20 October 2020

**New Plymouth District Council
Plan Change Application for 2 Johnstone Street, Waitara
Technical Review of Transport Matters**

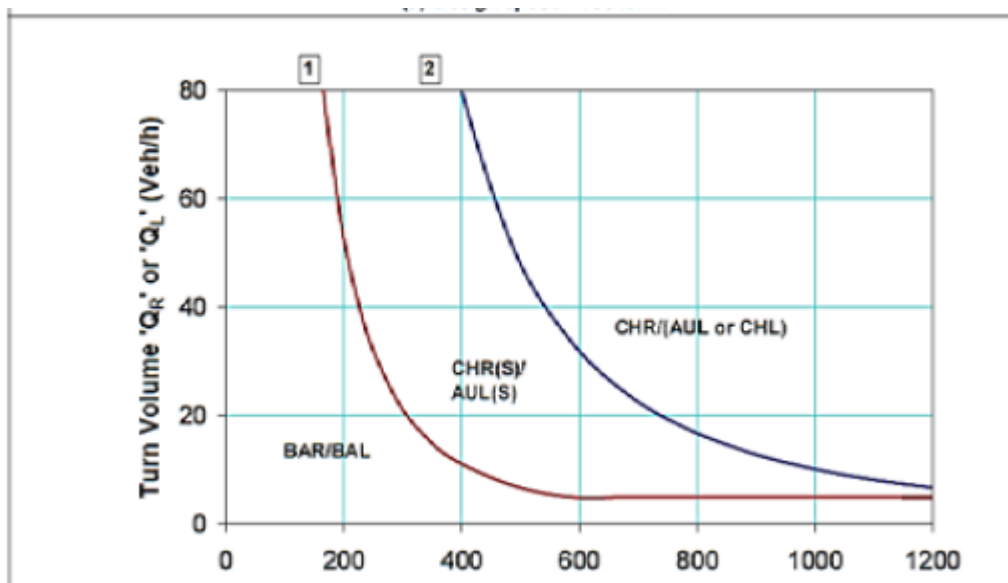
With regard to the Applicant's assessment of the form of the proposed new intersections (as set out in Section 10.3 and Table 10-1 of Appendix F1, I do not agree with this assessment for the proposed intersection. As a minimum a basic right turn treatment is required at each of the proposed intersections as specified in Figure 2.23 from Austroads part 6 (reproduced below).

As stated above, in meeting standards for the location of the proposed intersections and acknowledging that two separate intersections would not comply with standards in an 80 Km/hr speed restricted area, a method to remedy this non-compliance would be to provide a single access (intersection) to/from the proposed subdivision. This would require a channelised right turn treatment on Raleigh Street in accordance with Austroads standards for rural environments.

Alternatively, extending the speed environment to 50 Km/hr southwards to south of the Johnstone Street intersection would mean the two proposed intersections can be implemented in the general locations as set out by the Applicant and meet current standards, along with a basic right turn treatment. Extending the existing 50 Km/hr speed limit on Raleigh Street to south of Johnstone Street would also help address the safety concerns raised above in relation to property access to and from Raleigh Street for those properties abutting Raleigh Street.
